VERIFICATION REPORT

Khe Bo Hydropower Project

Report No. 01 997 9105080756
Version 03, 16 MAR 2015

Section A - Description of project activity
A3. Technologies and/or measures (page 3, revised PDD)

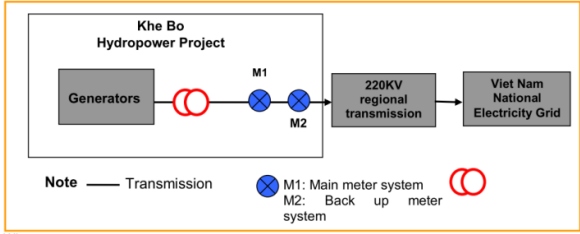
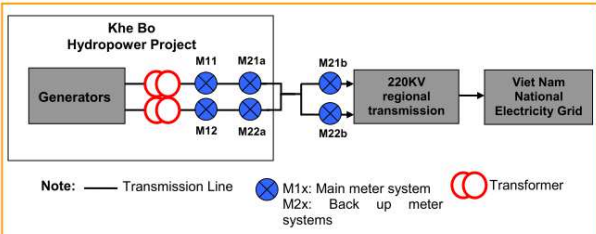
Post registration change - Corrections on Description of project activity	
Description in monitoring plan of the registered PDD or approved monitoring methodology	Permanent changes to the registered PDD based on the actual project activity with DOE assessment and reason of acceptance
<p><i>The corrections on the geocoordinates of project activity</i></p> <p><u>A.2.4. Physical/Geographical location</u></p> <p>Approximately 104°41'0"E east longitude and 19°8'0"N north latitude</p>	<p><u>A.2.4. Physical/Geographical location</u></p> <ul style="list-style-type: none"> - Dam: 104°39'46.74"E or 104.6630 East longitude and 19°10'52.66"N or 19.1813 North latitude - Power house: 104°39'51"E or 104.6642 East longitude and 19°10'35"N or 19.1764 North latitude. <p><u>Assessment by the DOE:</u></p> <p>The geocoordinates in the PDD was taken before the project was constructed therefore it is inconsistent with the actual coordinates. The coordinates in the registered PDD was actually taken at the resident location of project management board. At that moment, there was not yet any proper road to access to the dam and power house locations. Therefore, the coordinates reported in the PDD is just the approximation. The deviation between the coordinates in the registered PDD and the actual coordinates is approximately 2.5km which the verification team deems acceptable.</p> <p>The actual coordinates was updated in the revised /3/. During the verification onsite visit, the verifier has checked again using the GPS, the project participant also confirmed in the declaration letter /28/ therefore,</p>

The Verification Team finds that this correction do not affect the design of the project activity and emission reduction calculation, thus they are deemed as the correction that do not require prior approval by the board in accordance with Appendix 1 of Project Standard, Version 7.0.

Assessment by the DOE:
